UNITED STATES
DEPARTMENT OF THE INTERIOR
BUREAU OF LAND MANAGEMENTRECEIVED
OCD Artesia
MAY 07 2018
DISTRICT II-ARTESIAFORM APPROVED
OMB NO. 1004-0137
Expires: January 31, 2018**SUNDRY NOTICES AND REPORTS ON WELLS**
Do not use this form for proposals to drill or to re-enter an abandoned well. Use form 3160-3 (APD) for such proposals.**SUBMIT IN TRIPLICATE - Other instructions on page 2**

White City 8 Federal #1

API # 30-015-34785

Permanent Abandonment of Federal Wells
Conditions of Approval

White City 8 Federal #1

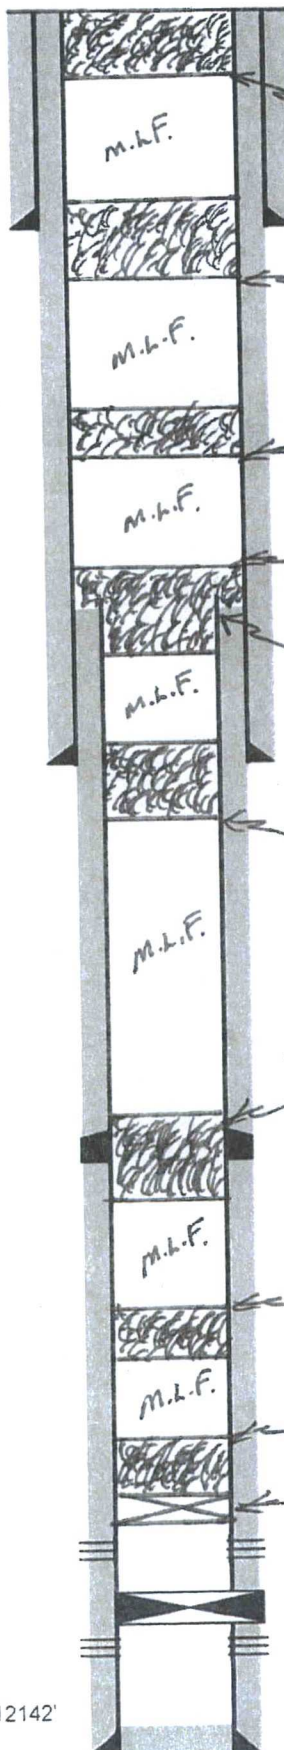
**SEE ATTACHED FOR
CONDITIONS OF APPROVAL***Add T/Salt for 725-625 woc tag
Regular**5-8-18*
Accepted for record - NMOCD
